Contract #: 04-0120F4
 Cty: SF/ALA Rte: 80 PM: 13.2/13.9
 File #: 69.25B

QUALITY ASSURANCE -- NON-CONFORMANCE REPORT

Report No: NCR-000432

Reference Description: Fabrication not according to the approved shop drawings

Component: Deck Panel Diaphragm at PP74

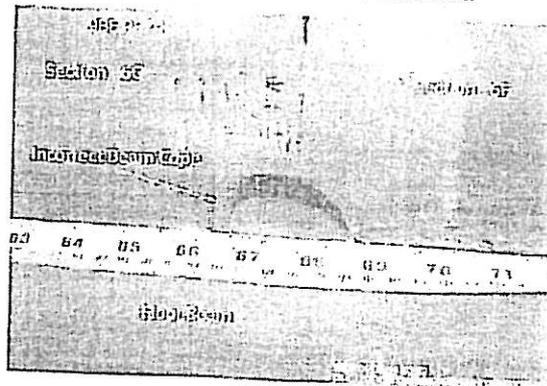
The Quality Assurance Inspector (QA) observed that the contractor deviated from approved drawing sheet no SEGSD16A by cutting a beam cope/weld access hole. This non-approved beam cope/weld access was cut into the Deck Panel Diaphragm at the vertical splice connecting plates DP501A to DP339A to the Floor Beam on segment 9BE at PP74. The splice is located approximately 1730mm measured from the end of Deck Panel.

项目名称 Project Name:	美国海湾大桥 SFOBB	部件图号 Drawing No.:	SEG052A	报告编号 Report No.	B-CWR731
合同号 Contract No.:	04-012DF4	部件名称 Item Name:	顶板连接板 Deck plate connect plate	NDT报告编号 Report No. of NDT	NA
项目编号 Project No.:	ZP06-787

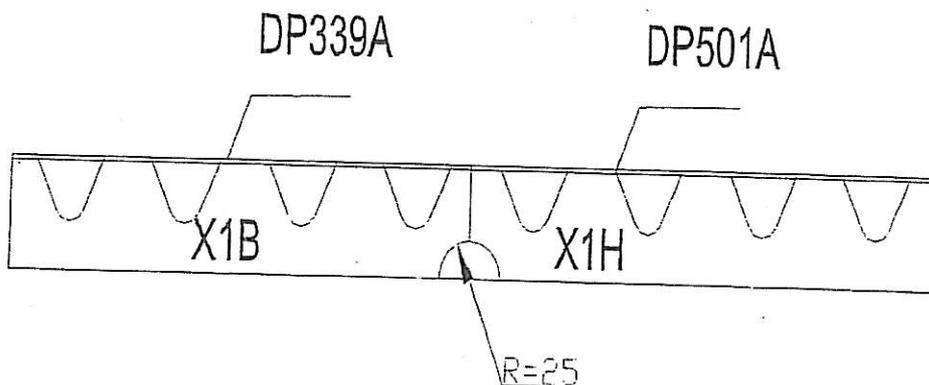
检查发现9BE的顶板DP501A的连接板X1H与顶板DP339A的连接板X1B对接缝下端多开R=25的过焊孔, 具体如下图所示:

After inspection: the r-hole was fabricated error at 9BE deck plate DP501A X1H and DP339A X1B, 25mm in radius, the detail see the following draft.

Worker didn't review drawing carefully caused weld through hole fabricated error.

1. QC and CWI should be present to witness the repair.
2. Repair to be perform in according with submittal 200 and letter No.:05.03.01-003474.
3. Elongate the hole by arc gouging, and grind smooth the surface. The elongated hole should conform to the joint detail in Repair WPS. Preheat before gouging according to relevant WPS.

4. Perform VT and MT to ensure no defects exist.
5. Add steel backing. Preheat and perform root welding according to the repair WPS, weld stringers longitudinally along the elongated direction of the hole. Grind the weld to make it have a smooth transition with adjacent base metal.

6. Perform MT before following operations to ensure no defects exist.
7. Preheat and weld according to repair WPS.
8. Remove steel backing and back gouge the root pass, and complete the welding.

9. Grind the repair area flush with adjacent base metal.
10. Check with VT, UT, MT after welding to the repair area.

MT AFTER BACK GOUGING TO ENSURE BACK GOUGING IS FREE OF DEFECT
 9-17-09
